CITY OF GARDEN CITY

File Number: DSRFY2020 - 29
Application Scope: Formal Design Review Hearing for Service Provider Development
Location: W. Chinden Blvd.
Applicant: Jeff Hatch
Pre-App Report Date: October 5, 2020
Revision Date: October 19, 2020

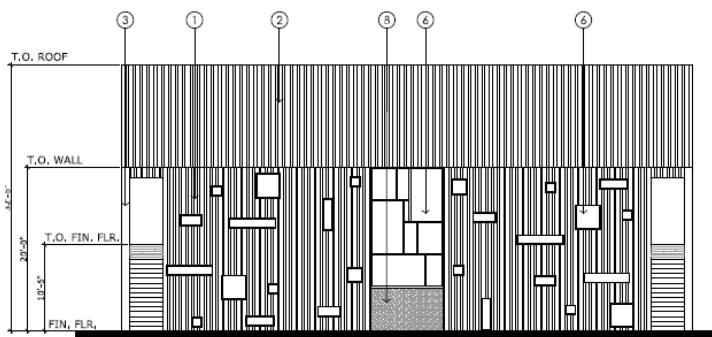
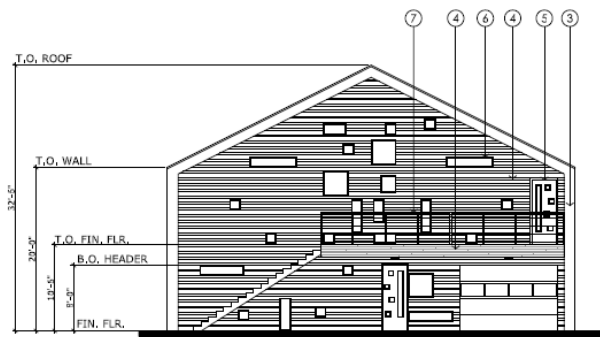
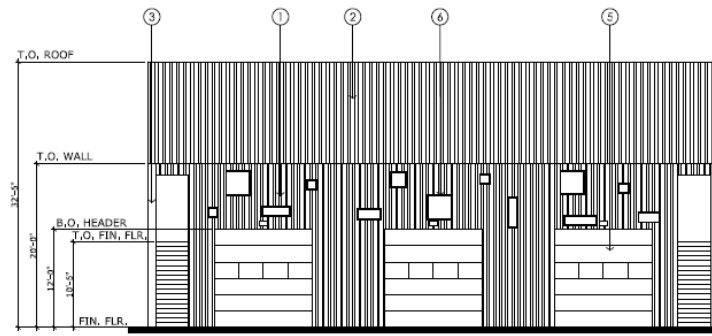
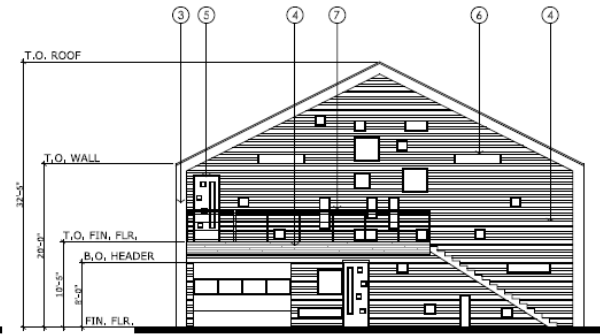
The applicant has added plaza elements facing Chinden Blvd., a slightly revised landscape plans, new building elevations, and building materials have been identified.

<ul style="list-style-type: none"> • Matte black metal wall panel siding • Matte black metal standing seam roof • Matte black metal fascia • Horizontal wood siding • Matte black door • Black anodized aluminum window • Black powder coated steel railing • Texturized grey concrete <p><i>Objective 4: The site design shall respect existing notable site features including existing buildings, landscaping, trees and water.</i></p> <ul style="list-style-type: none"> • No comment. It is a vacant lot. <p><i>Objective 5: The design of all buildings shall provide visual interest, support the vision for the area as articulated in the comprehensive plan and positively contribute to the overall urban fabric of the community.</i></p> <ul style="list-style-type: none"> • Per the Design Review Committee's previous comments in the pre-app, the proposed windows and their placements on the existing elevations aid in meeting these standards. <p><i>Objective 6: The site development should support and be consistent with the adopted streetscape.</i></p>
